PRODUCT / PROCESS CHANGE NOTIFICATION

1.1 Company	 STMicroelectronics International N.V
1.2 PCN No.	MDG/23/13703
1.3 Title of PCN	ST Shenzhen (China) TSSOP20 package copper alloy bonding wire introduction on STM32G03x and STM32G04x listed products
1.4 Product Category	STM32G03x STM32G04x
1.5 Issue date	2023-01-22

**PRODUCT/PROCESS
CHANGE NOTIFICATION
PCN13703 – Additional information**

**ST Shenzhen (China) TSSOP20 package
copper alloy bonding wire introduction on
STM32G03x and STM32G04x listed products**

Standard marking example:

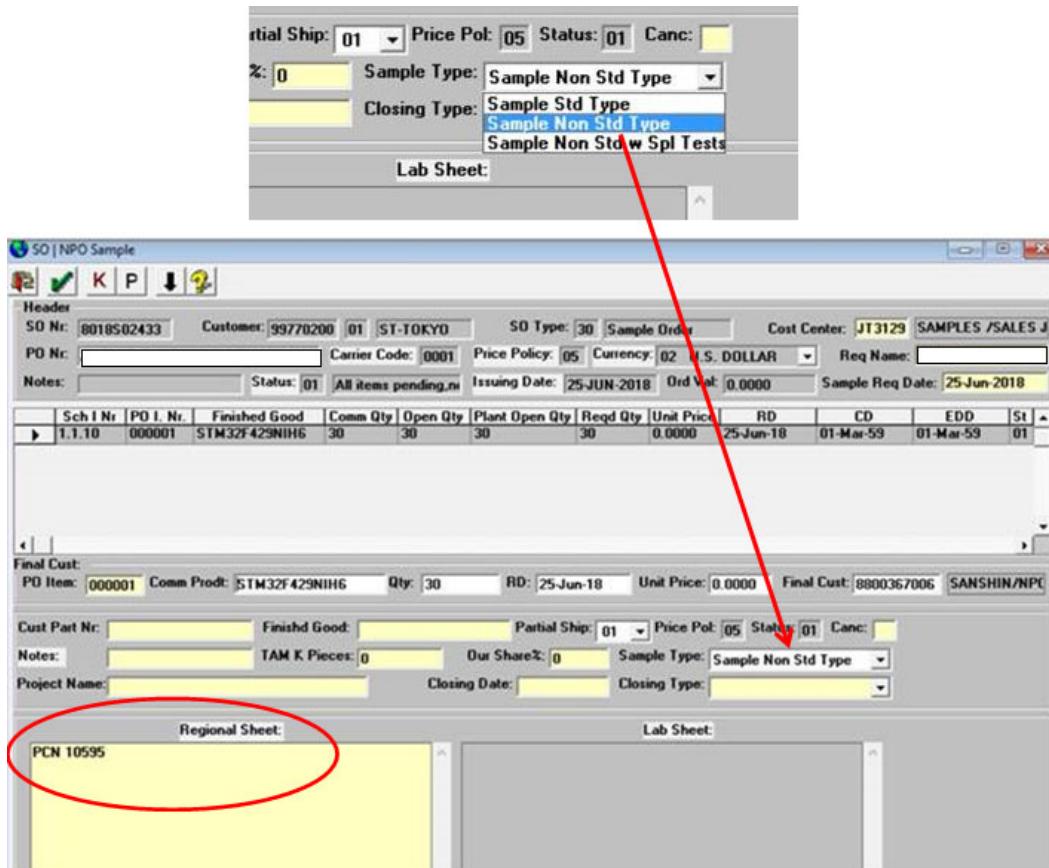
How can the change be seen?

Traceability ensured by ST internal tool.
